TITLE		162FBGA, 8. 0X10. 5mm, 0. 30BALL, 0. 50PITCH, 0. 37CAP. , 0. 80THICKNESS		
			DES. BY	대리 / 남우식	18. 04. 03	DWG. NO	GPD0209
CHE. BY			REV. NO	UNIT	SCALE	SHEET	
DRA. BY			3	MM	1/1	1/1	
APP. BY	차장 / 임동욱	18. 04. 03

SIDE VIEW

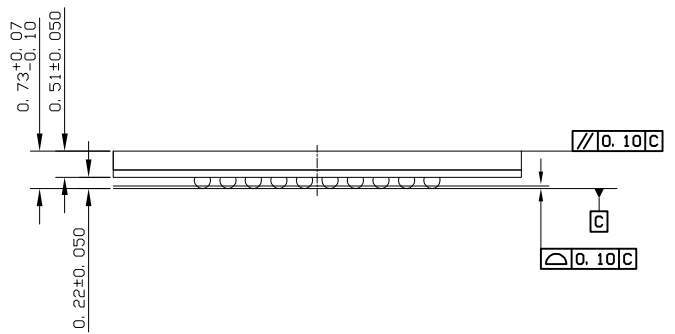
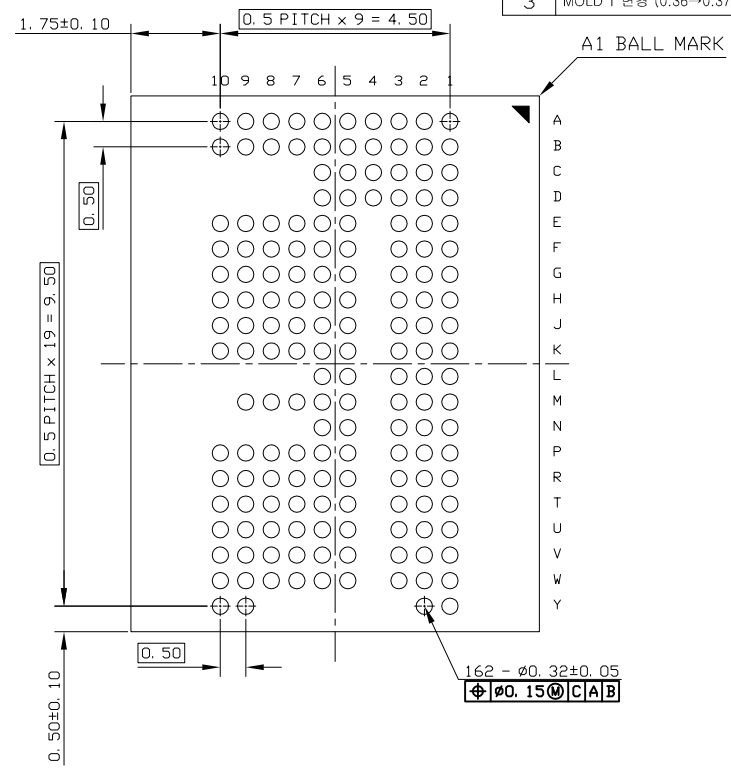
NO	변경 내용
1	MOLD, TOTAL THICKNESS 변경 (0.34→0.36 / 0.7→0.72)
2	TOTAL THICKNESS 상한 공차 변경(0.1 → 0.08)
3	MOLD T 변경 (0.36 →0.37), 상한 공차 변경 (0.08 → 0.07)
